Subject: Request for Approval – Revision to Powdered Activated Carbon (PAC) Injection Location at Racine Water Treatment Plant, Racine Water Utility, Wisconsin

On behalf of the Racine Water Utility, this letter serves as notification and request for approval of a proposed revision to the powdered activated carbon (PAC) injection point at the Racine Water Treatment Plant, located in the City and County of Racine, Wisconsin.

Figure 1 – Existing PAC Feed Piping

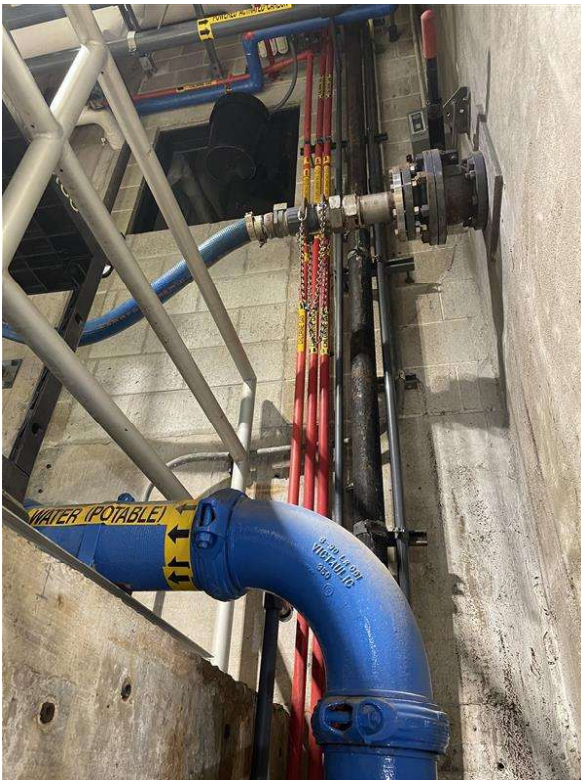
The existing PAC runs in the blue flexible pipe as shown in Figure 1. Racine Water Utility proposes to replace the 10 lineal feet of flexible 4-inch piping with rigid PVC piping and extend a vertical 2-½- inch flexible pipe from the 4-inch PAC feed line to the existing injector connection shown in Figure 2.

Figure 2 – Existing Filter Aid Polymer (FAP) Injection Tap on the Raw Water Line.

The Filter Aid Polymer addition is not currently utilized by the Racine Water Utility and this injection point can be repurposed.

Figure 3 – Proposed Injection Point Schematic Location

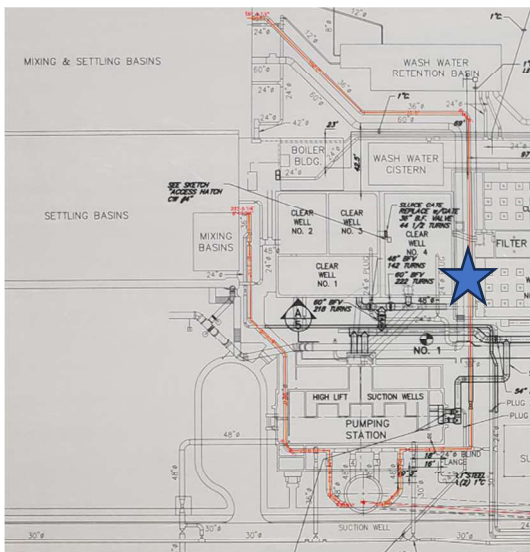
The Racine Water Utility proposes to relocate the PAC injection point to the raw water main prior to the sedimentation basins, thereby providing increased contact time for adsorption of taste and odor compounds while reducing direct PAC exposure to the membrane system. The CT from the settled riser box area to mixing basins 1 and 2, where coagulant is added and the PAC effectiveness essentially reduced, would be 2.0 minutes at historical average flow (17.1 MGD) and 1.1 minutes at historical maximum flow (29.4 MGD). Key elements of the proposed revision include:

The proposed injection point would be located approximately as shown in Figure 3.
